Produktänderung Neues Elektrodendesign bei EF-Serie von EPCOS 2-Elektroden-Ableitern

Product / Process Change Notification

**Annex to UPtoDATE 150605AB1 of June 5, 2015 /
New electrode design for EF series of EPCOS 2-electrode surge arresters**

Veränderungen an der Elektrode

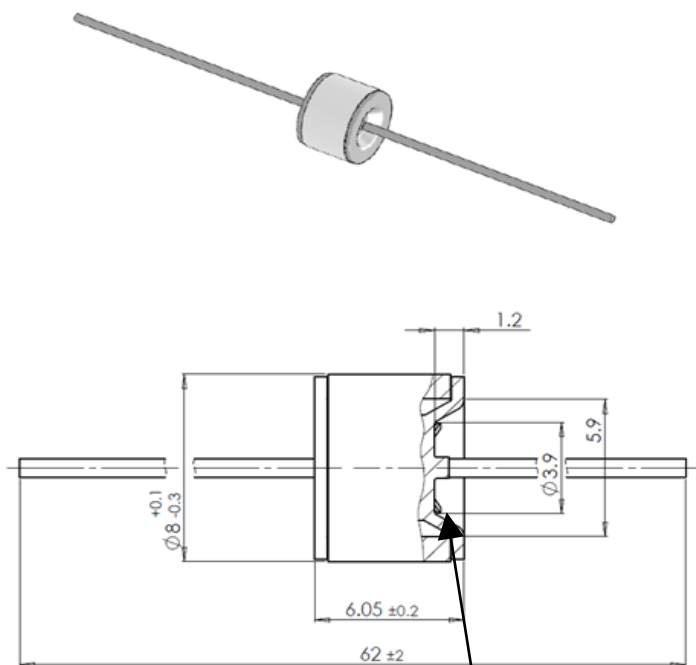
Bei den EPCOS 2-Elektroden-Ableitern der EF-Serie aus dem Werk in Xiaogan, China, wird das Design der Elektroden geringfügig abgeändert. Die Maße der Bauelemente bleiben dabei im Wesentlichen gleich. Darüber hinaus hat die Änderung der Elektroden keine Auswirkung auf die Verarbeitung der Bauelemente beim Kunden.

Beschreibung	Bisher	Neu
Elektrodenkalotte	Ø 3,9 mm Ø 5,9 mm	Ø 2,8 mm Ø 5,2 mm

Comparison of old and new electrodes

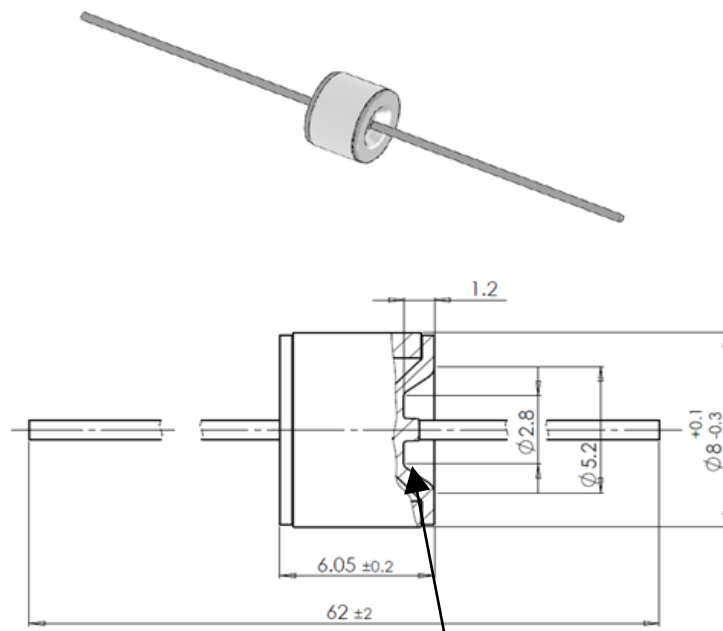
4. Description of change: The design of the electrodes will be slightly changed. The dimensions of the component remain unchanged, except for minor modifications to the calotte of the outer electrode. The aim of the new electrode design is to further improve the electrical performance of the product (see drawing for details).

Old electrode design

New electrode design
